Staff Report & Recommendation

SUBJECT: HPB23-0592, **624 Collins Avenue.**

An application has been filed requesting a Certificate of Appropriateness for the construction of a 1-story rooftop addition and design modifications to the building.

The applicant has submitted plans entitled “Isabelle’s Restaurant”, as prepared by Beilinson Gomez Architecture, dated September 11, 2023.

1923 Photograph

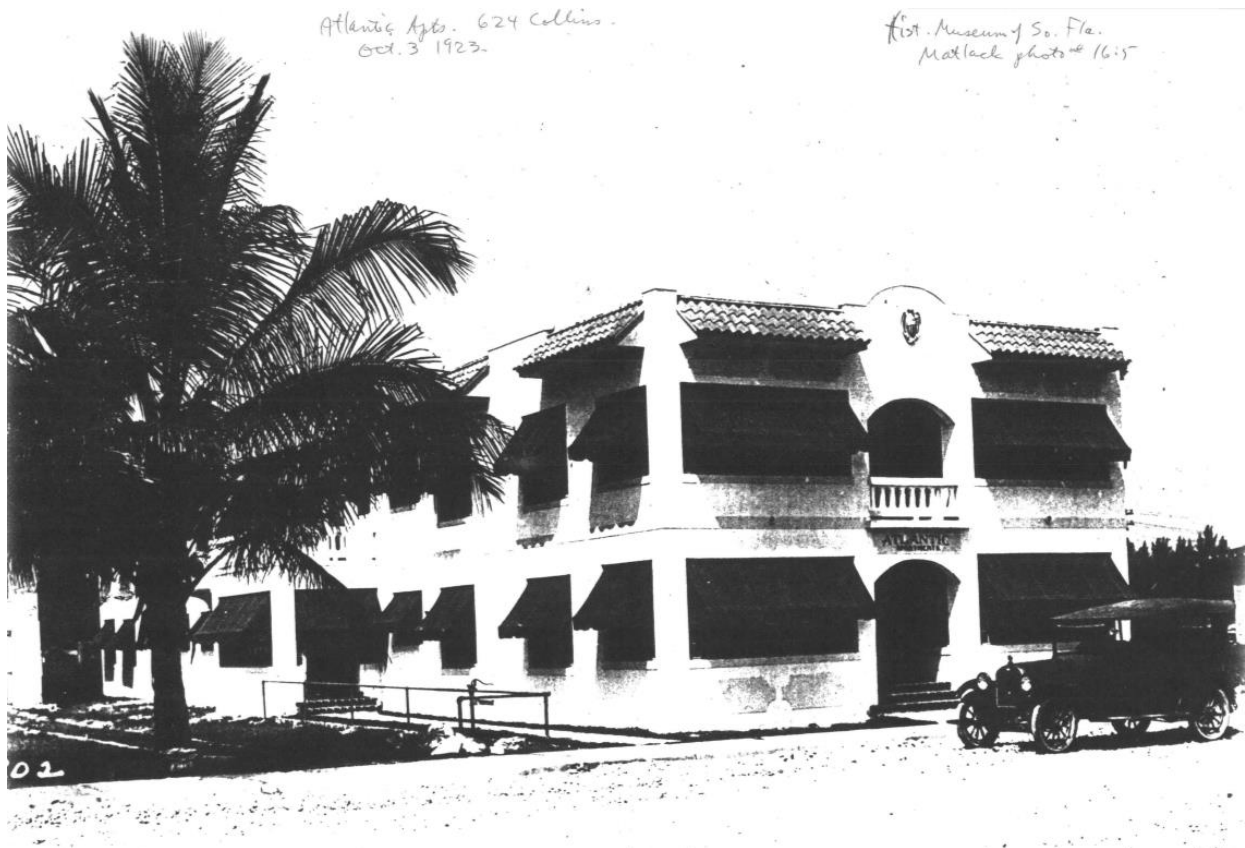
Staff has only two concerns relative to the proposed project. First, in order to address the Sea Level Rise and Resiliency Criteria, staff recommends that the applicant explore raising the lower rear portion of the first-floor level (currently 6.68' NGVD) to match the higher elevation at the front of the building (8.00' NGVD); to make the building less susceptible to the effects of future sea level rise. Second, at the second level of the Collins Avenue façade, the applicant is proposing to enclose the open-air porch including the removal of the existing decorative balustrade. Although the balustrade is not original, it was designed in a manner somewhat consistent with historical documentation. Staff has no objection to the proposed enclosure of the porch with glass but does

recommend that a new balustrade be introduced on the outside of the glass that more closely resembles to the original design in order to maintain the proportions of the primary façade

- b. A new balustrade shall be introduced on the outside of the proposed storefront glass enclosure at the second level along Collins Avenue in a manner consistent with available historic documentation, in a manner to be reviewed and approved by staff consistent with the Certificate of Appropriateness Criteria and/or the directions from the Board.
